**Advisory Action
Before the Filing of an Appeal Brief**

10/702,198

WALKER ET AL.

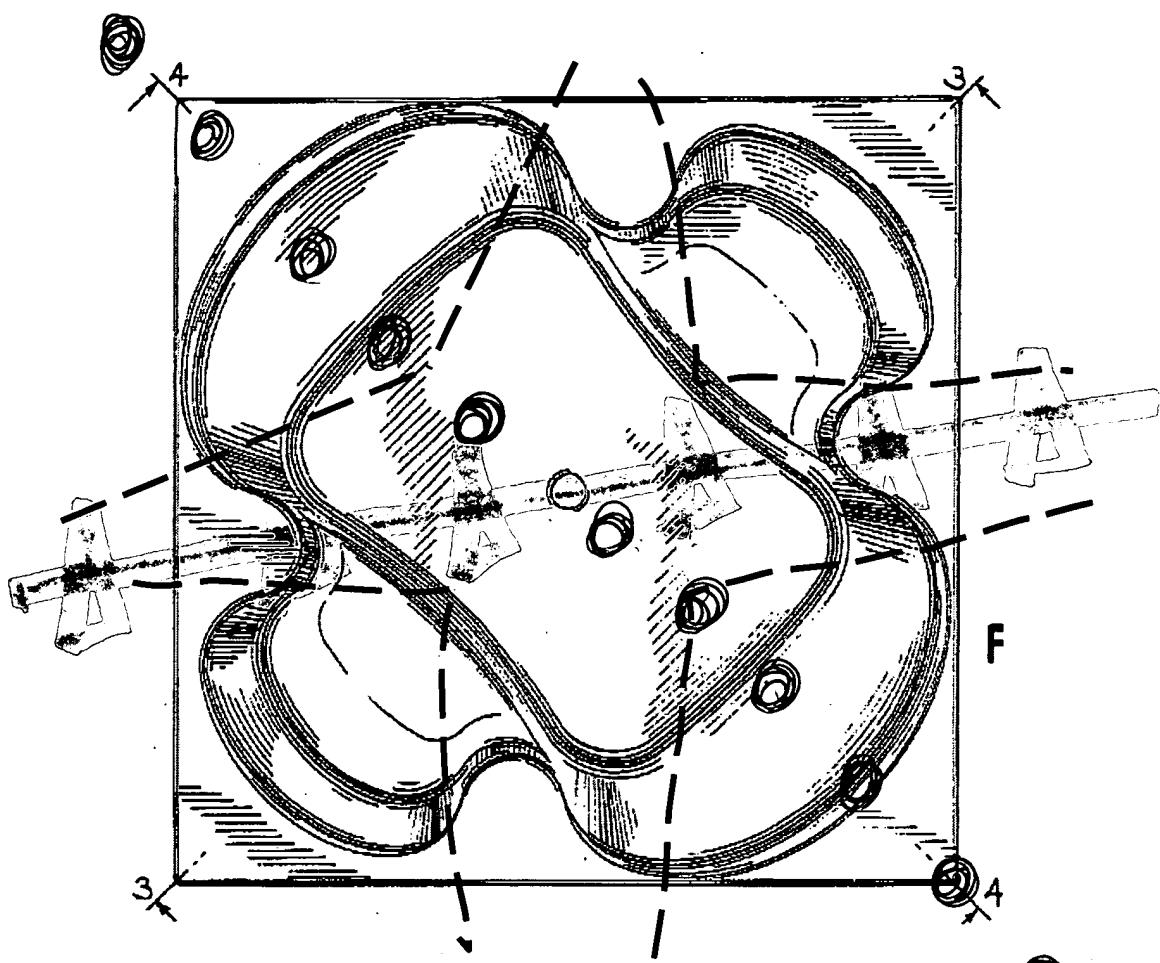
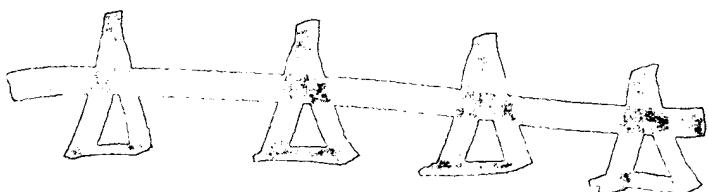
Continuation of 11. does NOT place the application in condition for allowance because: the dashed lines were not intended to represent axis lines, but to show 4 curved sidewalls convex to the interior (the 4 sections each "enclosed" by each dashed line) and 4 rounded corners concave to the interior (the four sections remaining and not enclosed by the 4 dashed lines). The axis bisecting the side walls and the axis bisecting the corners would be drawn thru 2 opposite corners and 2 opposite sidewalls. Examiner notes that "substantially symmetrical" can include an exact mirror image that is rotated 180 degrees, as is the case of the symmetry of the sides bisected by the axis bisecting the interior through 2 corners. See attached for axis lines..

axis thru sidewalls

axis thru corners
